Re: 49 CFR Part 573; Recall of Mercedes-Benz Rear Load Leveling

TO: Mercedes-Benz Dealer Principals, General Managers, Sales Managers, Service Managers, Parts Managers	FROM: Thomas Brunner; Department Manager; Vehicle Compliance and Analysis; Engineering Services
RE: : Recall Campaign 2012070006 – Check Level Sensor Linkage at Rear Axle, Replace if Necessary, Model 211 Wagon, Model Years 2007- 2009	DATE: August 31, 2012

SUBJECT: **Model 211 Wagon, Model Year 2007 - 2009**
Check Level Sensor Linkage at Rear Axle, Replace if Necessary

Figure 1 Open ball head

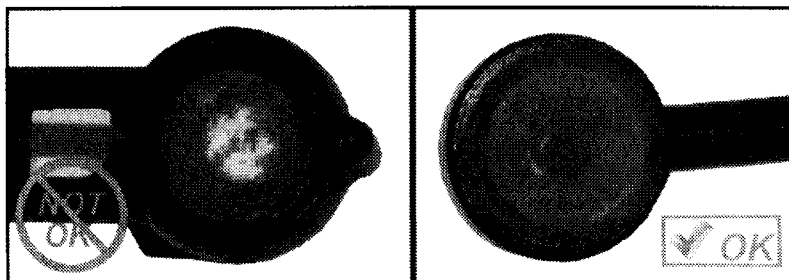
1. If closed ball head **IS** installed (OK, Figure 1): Procedure is complete.
2. If closed ball head is **NOT** installed (NOT OK, Figure 1): Proceed to subject B: **Install New Level Linkage**.

Figure 2

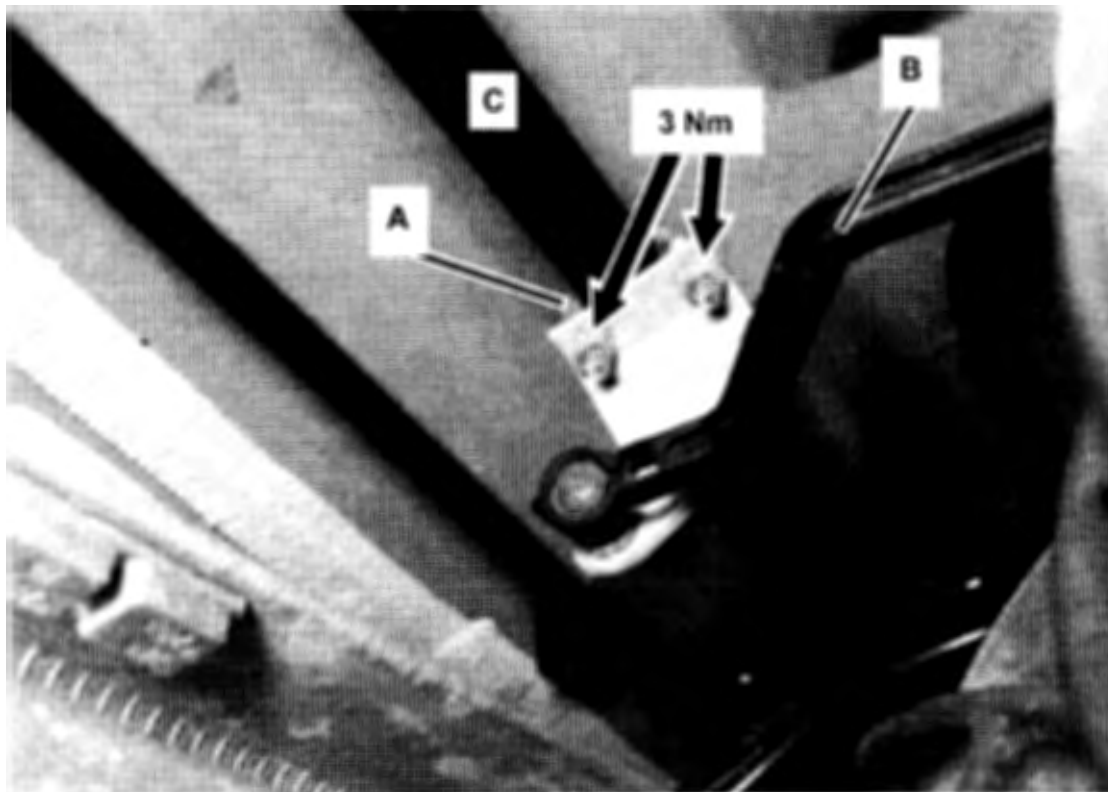
1. Unscrew U-bracket (A, Figure 2) for level linkage (B) at stabilizer bar (C).

Note: Torque new nuts (arrows, Figure 2) to 3 Nm when installing new level linkage assembly (B, Figure 2).

Figure 4

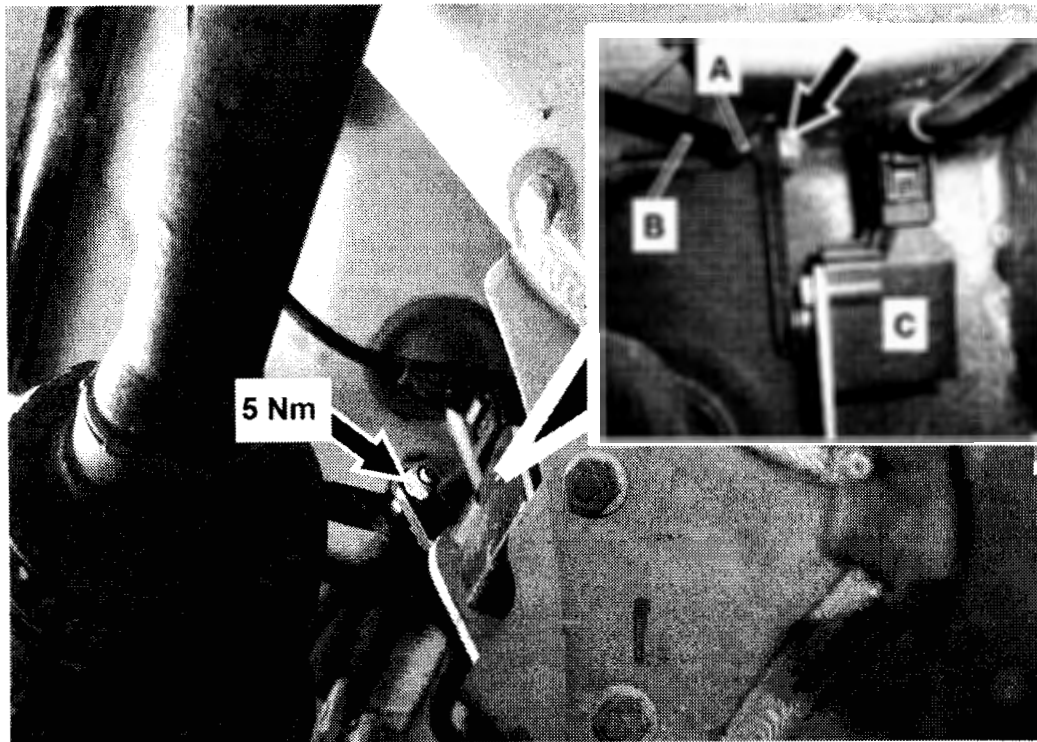
- Counter hold ball head (A, Figure 4) with open end wrench then unscrew level linkage (B) from level linkage sensor (C).

- Install new level linkage assembly (B, Figure 4) in reverse order,

Note: Torque new nut (arrows, Figure 4) to 5 Nm.

Figure 3

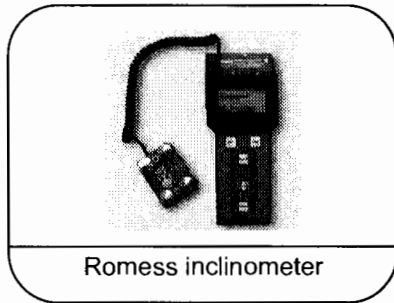
Observe installation position of bell crank (A, Figure 3) during assembly. When securing the U-bracket (B), the surface of the bell crank (A) must make contact at the face (arrow) of the stabilizer bar (C).
